South Texas Project
Units 3 and 4
Docket Nos. 52-012 and 52-013
Supplemental Response to Request for Additional Information

RAI 03.07.01-27, Supplement 3**QUESTION:****Follow-up Question to RAI 03.07.01-19 (STP-NRC-100093)**

RAI 03.08.04-30 Supplement 2**QUESTION:****Follow-up to Question 03.08.04-23**

Figure 3H.6-231: SSI, SSSI, ASCE 4-98 and Design Lateral Seismic Soil Pressures on Diesel Generator Fuel Oil Storage Vault No. 1A West Wall

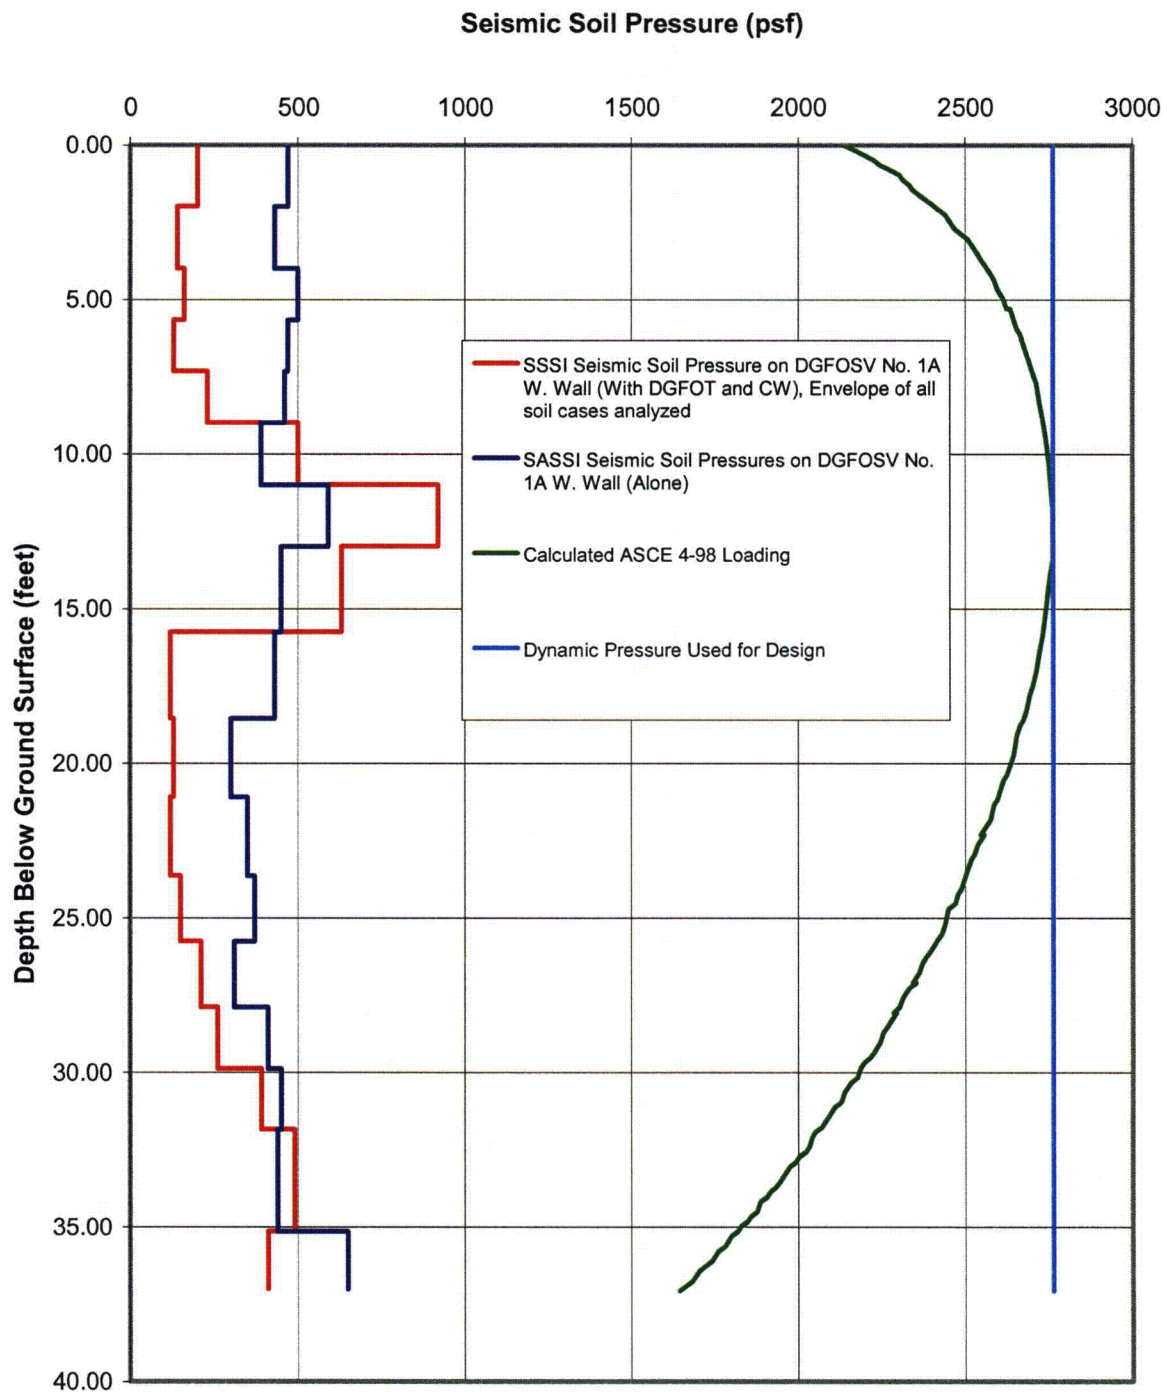
Review of responses to RAI 03.07.01-27, Supplements 1, Revision 1 indicates that two 2D SSSI models (East-West and North-South Sections) are analyzed to evaluate the effects of nearby structures on the three DGFOVSs and calculate the seismic soil pressures. In the East-West direction 2-D SSSI DGFOVS model (DGFOT 1C + DGFOVS 1A + CFRW), five cases of soil and backfill properties are considered to evaluate the effects of the soil and backfill properties variation. Also response to RAI 03.07.01-27, Supplement 2, Revision 2 indicates that in the East-West direction for DGFOT 1A (RB + DGFOT 1A + CFRW), five cases are run with various combinations of soil and backfill properties. However, in the North-South direction (UHS/RSWPH + RSW Tunnel + DGFOVS 1B + DGFOVS 1C + RB), only one case was run with UB soil properties. Also as discussed in response to RAI 03.07.02-24, Supplement 1, Revision 1, in the East-West direction for dynamic soil pressure evaluation for RSW Tunnel and RWB walls, the 2 D SSSI model (RB + RSW Tunnel + RWB) included only the UB in situ soil without any evaluation for backfill properties. As such, the applicant is requested to demonstrate that consideration of only UB soil profile instead of using a combination of UB soil and backfill parameters for the cited cases will still be conservative for the wall design of all site specific Category I and RWB structures (UHS/RSWPH, DGFOVS, RSW Tunnel, UHS/and RWB). The applicant is also requested to include this evaluation in the applicable sections of the FSAR.

The following revised COLA figures showing SSSI soil pressures, based on envelope of all soil cases analyzed, are provided in the Enclosure.

Control Building:	Figure 3A-302
Reactor Building:	Figures 3A-301, and 3H.1-1 through 3H.1-6
Radwaste Building:	Figures 3H.3-50 and 3H.3-51
RSW Piping Tunnel:	Figures 3H.6-212 through 3H.6-217
UHS/RSW Pump House:	Figures 3H.6-218 through 3H.6-220
DGFOSV:	Figures 3H.6-226 through 3H.6-231
DGFOT:	Figures 3H.7-5 through 3H.7-8

Figure 3H.7-5: SSI, SSSI, ASCE 4-98 and Design Lateral Seismic Soil Pressures (psf) on Fuel Oil Tunnel East Wall with Reactor Building and Crane Wall

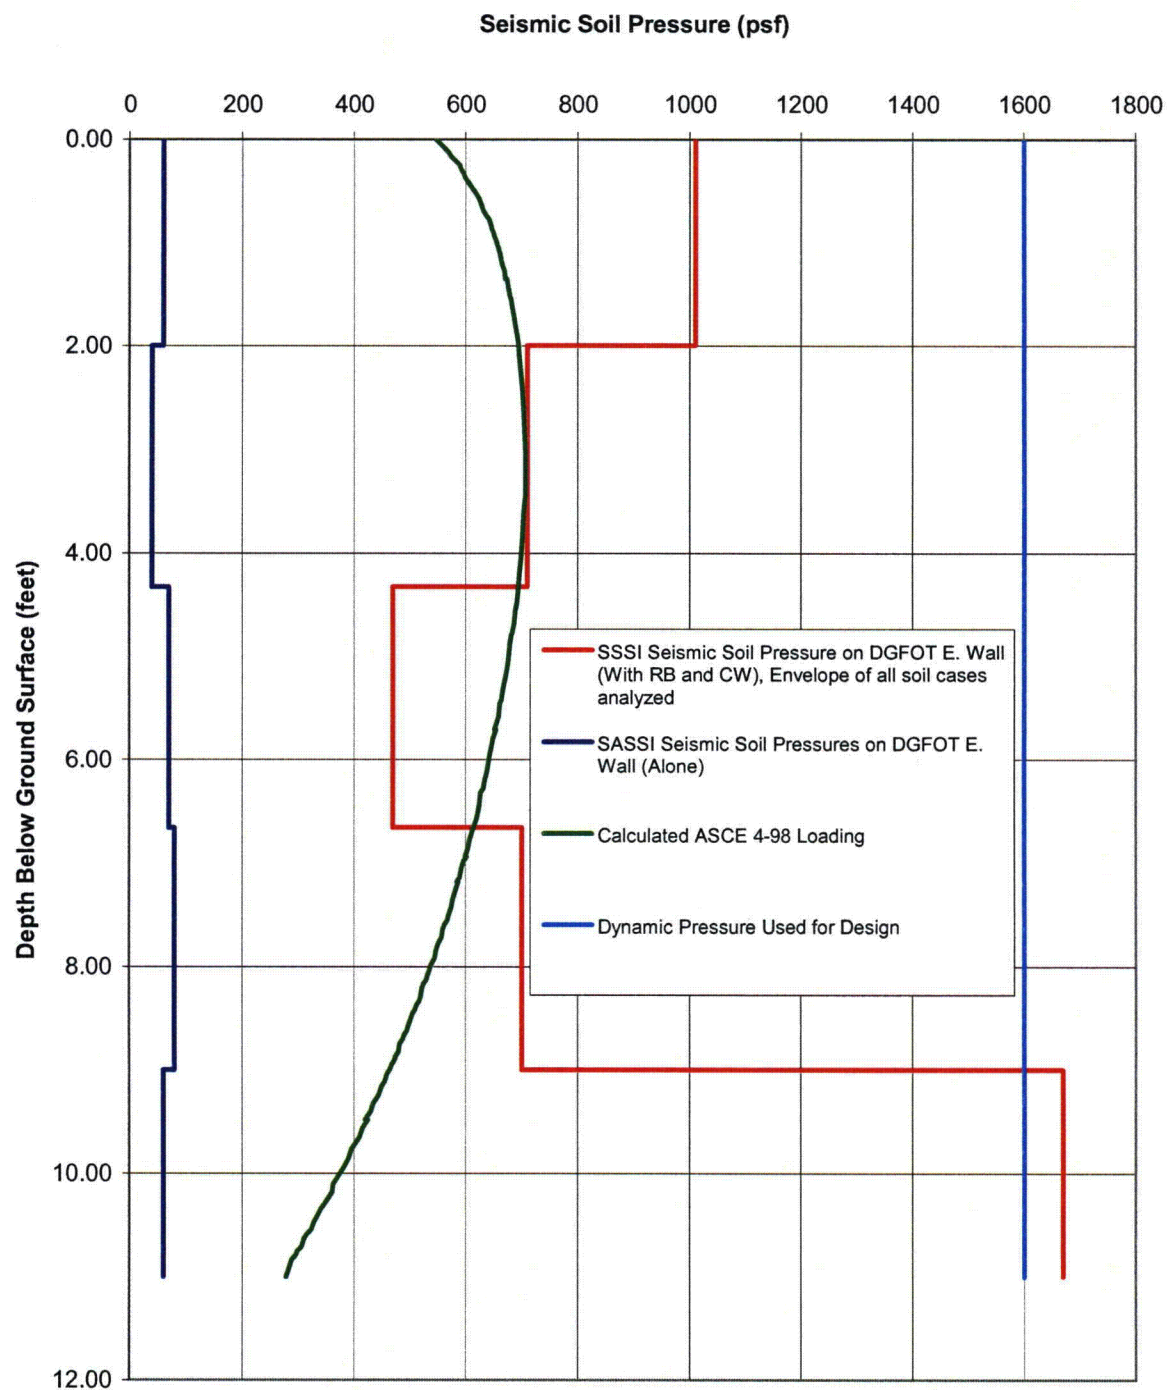
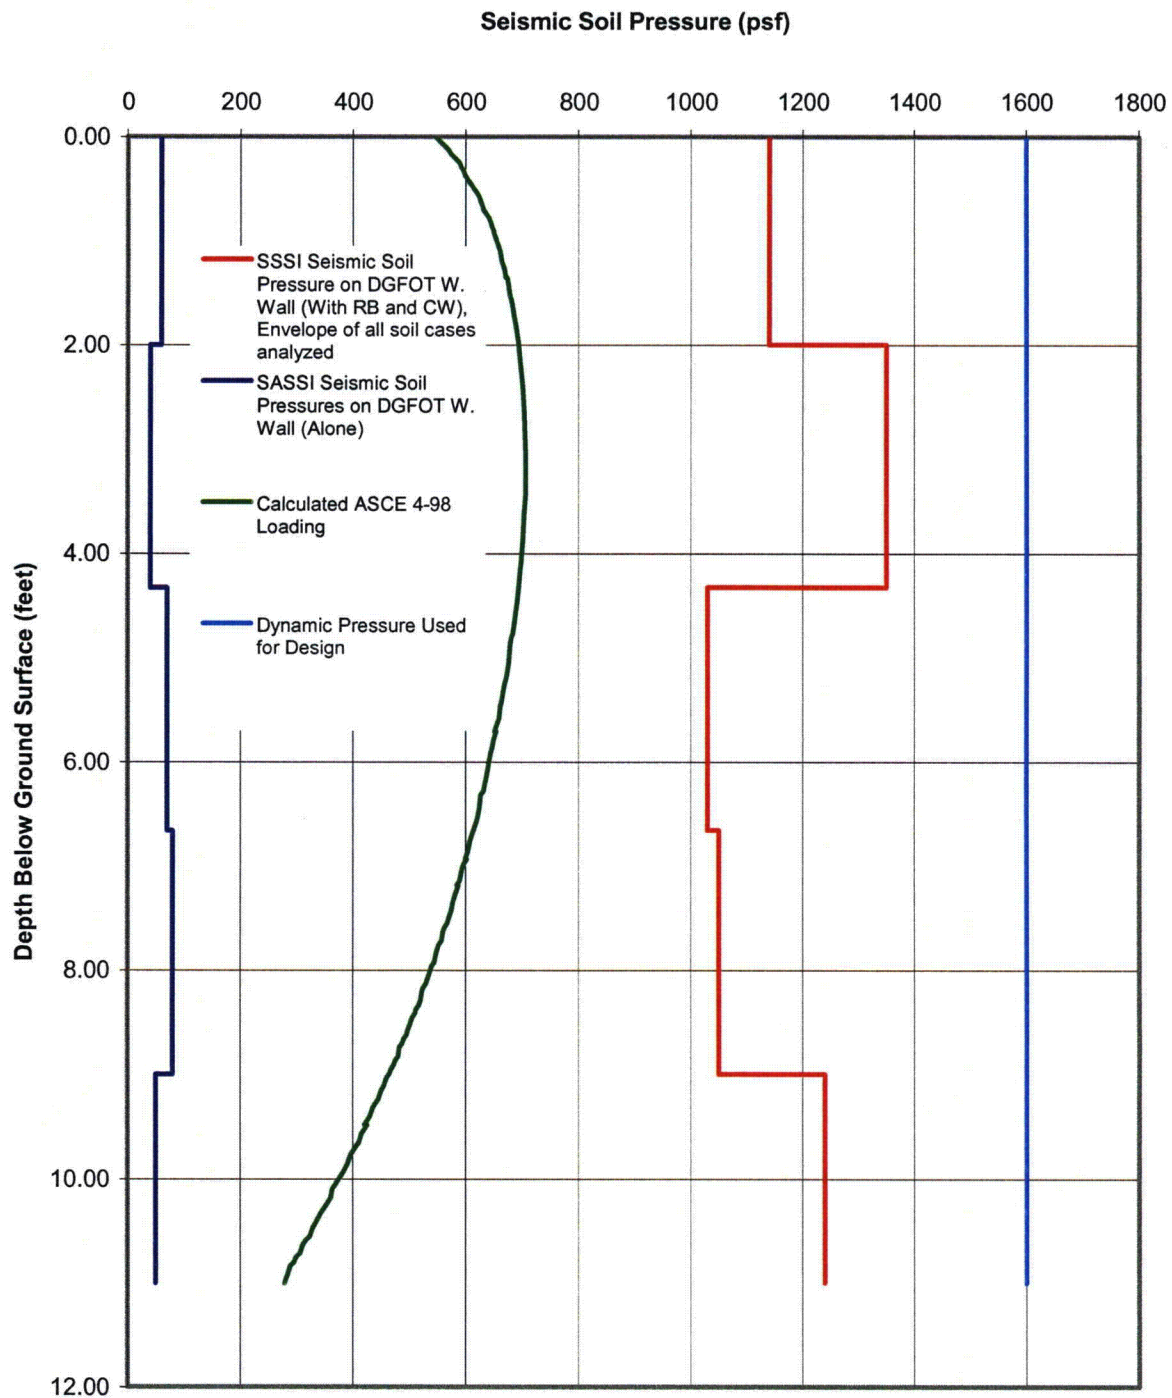
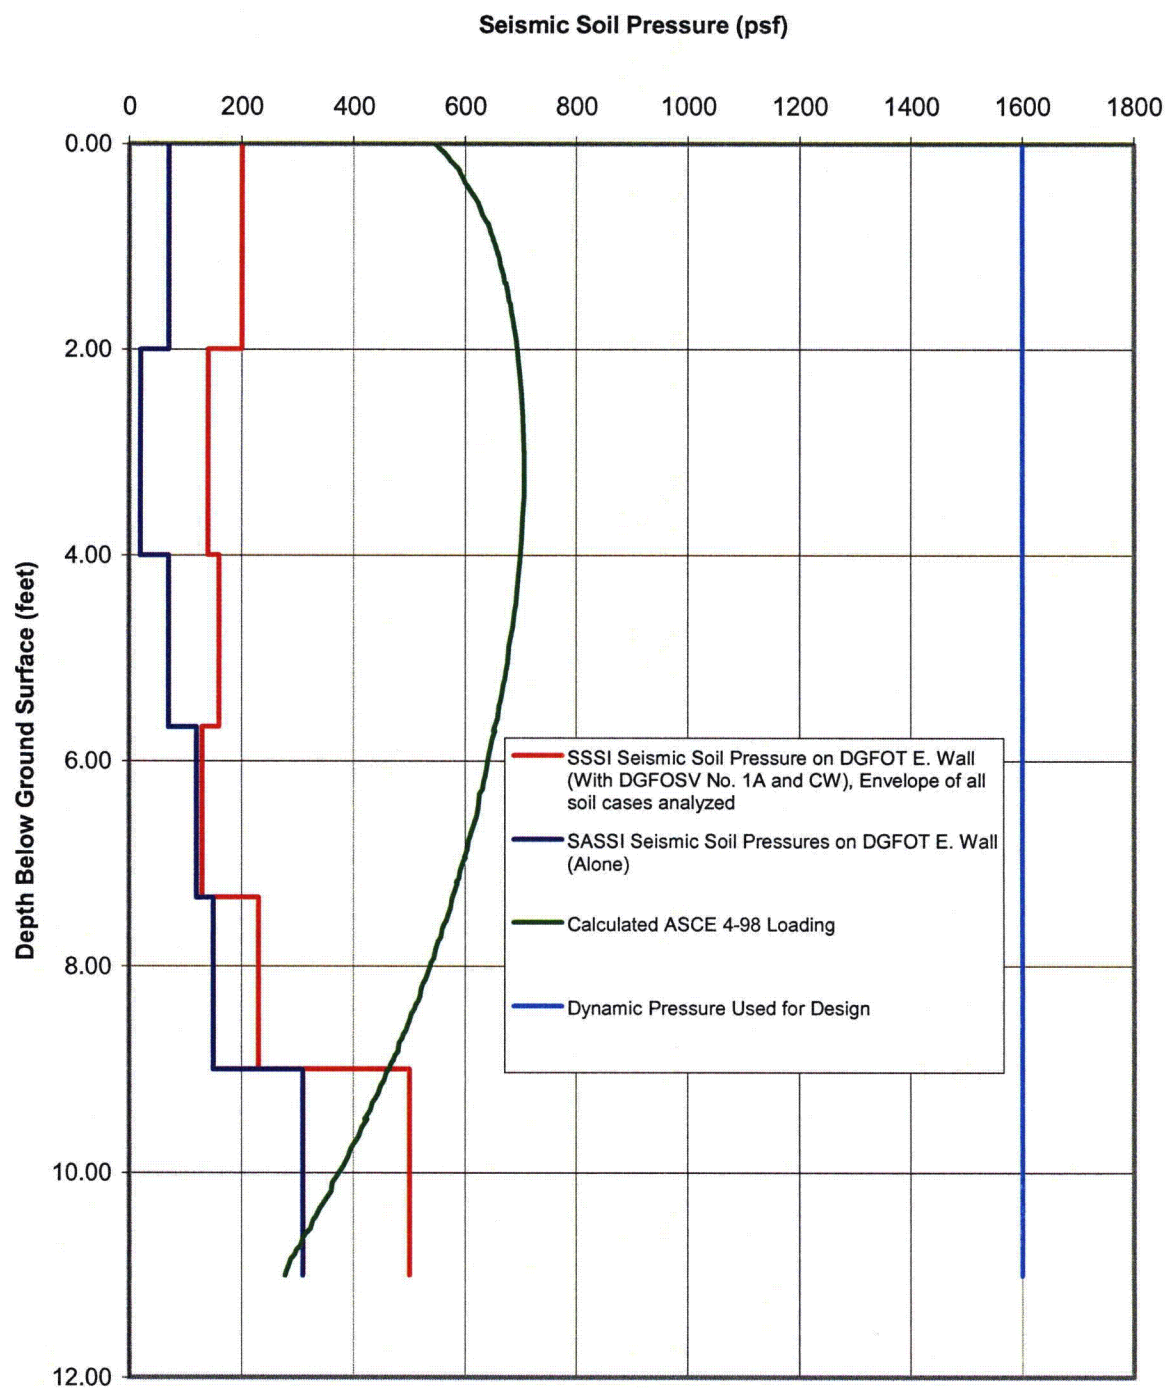
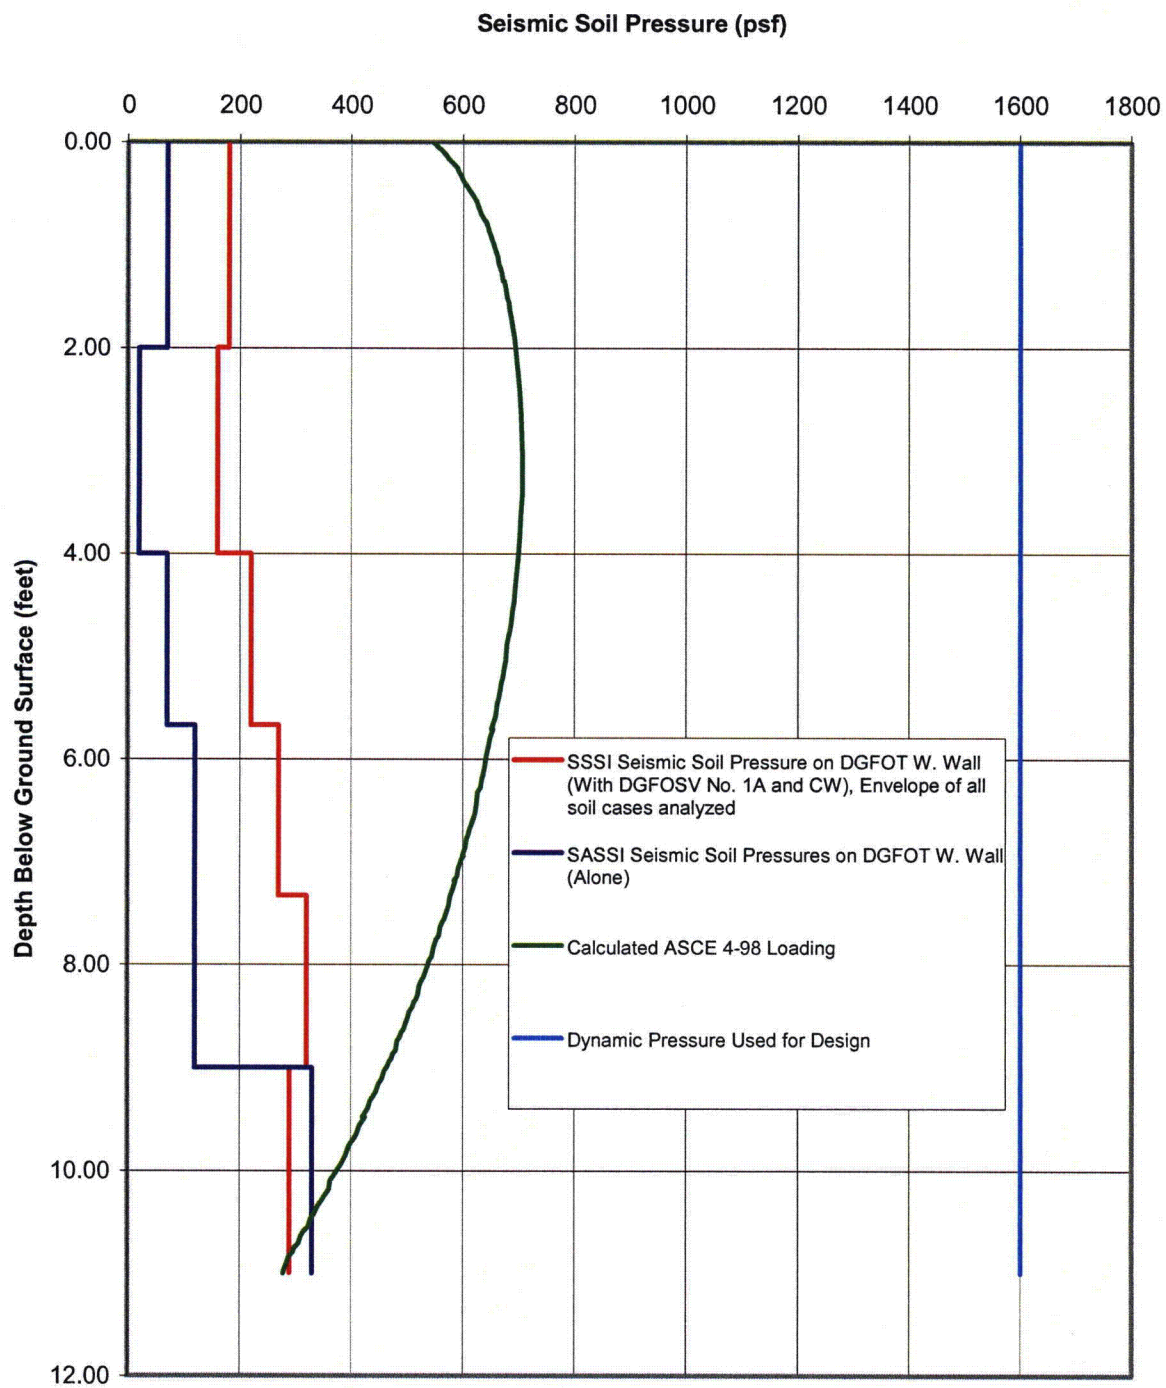
NINA was requested to discuss the soil cases for which the SSSI analyses for the RSW Piping Tunnel, DGFOVS, and DGFOT were performed. These cases should, as a minimum, include the upper bound in-situ and backfill soil cases. NINA was also requested to clarify the SSSI soil pressure figures in COLA to indicate that those represent envelop of all soil cases analyzed (Audit Action Items 3.7-6, 8, 10, and 36). Finally, NINA was requested to provide information regarding the following Clarification Issue 2, as provided by the NRC.
